August 1, 2012

RE: Revised Response to May 10, 2012 Comments  
Rhode Island Department of Environmental Management  
Draft Remedial Action Work Plan  
Former Gorham Manufacturing Facility – Park Parcel (a.k.a. Parcel C-1)  
333 Adelaide Avenue, Providence, RI  
Case No. 200-059 (Associated with Case No. 97-030)

Textron, Inc.  
Former Gorham Manufacturing Facility – Park Parcel (a.k.a. Parcel C-1)  
333 Adelaide Avenue, Providence, RI  
Response to May 10, 2012 RIDEM Comments – Draft Remedial Action Plan

DECONTAMINATION PAD  
 DEWATERING PUMP DETAIL

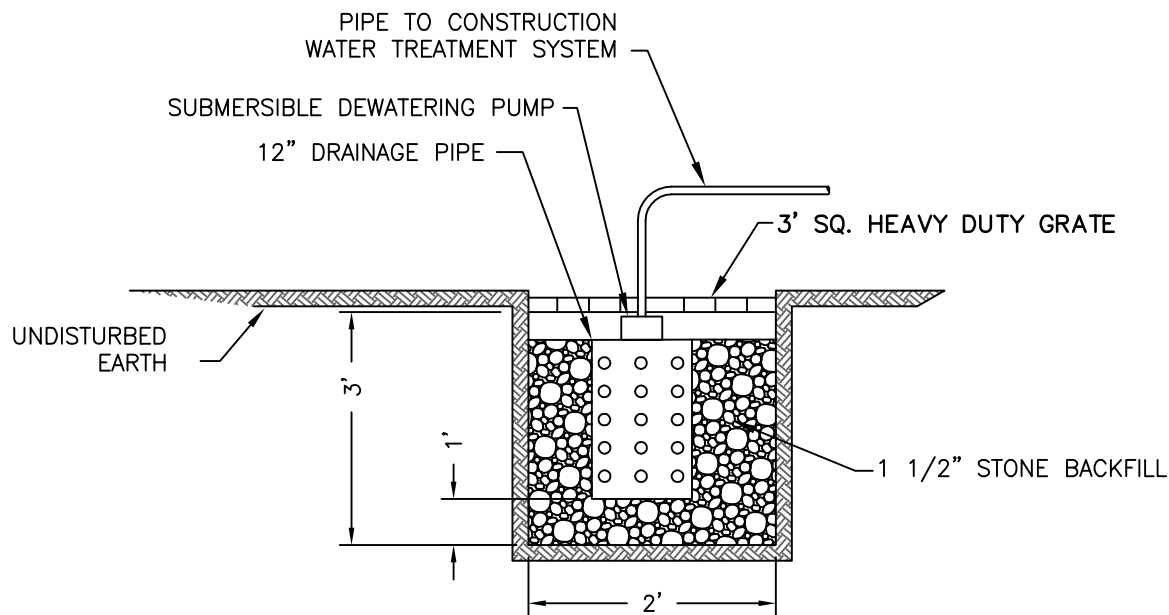
- b) Regarding Part 1, item 101.A.2.f – Decontamination pad – Please provide additional details about the decontamination pad, including its planned dimensions, construction details (i.e., liner specifications, secondary containment and/or runoff controls, etc.), and proposed location.

**RESPONSE:** *ET&L is proposing to construct vehicle access pads at all three entrances to clean the vehicle tires and to lay down clean gravel over the two laydown areas. Vehicles working within the contaminated soil area will remain in those areas until their work is complete and they will be decontaminated prior to removal from the site. Vehicles entering the site delivering clean material to the site will pass over the vehicle access pad and only operate on the clean gravel surface. Once the construction is complete and the vehicles are leaving the contaminated areas they will be decontaminated. If a decontamination pad is required, the contractor will install a gravel road base with a woven liner for trucks loading/unloading/hauling clean material.*

*A typical decontamination pad detail is shown in the two attached figures and is approximately 50-feet by 50-feet in size. Large enough to ensure that the vehicles are completely located on the pad. Specification Section 01354 also includes details for the decontamination pad such that high-pressure steam and water sprays shall be performed in a bermed and lined area. The decontamination area shall have a sump to collect decontamination water and be equipped with pumps to transfer the decontamination water to haul trucks for off-site disposal.'*
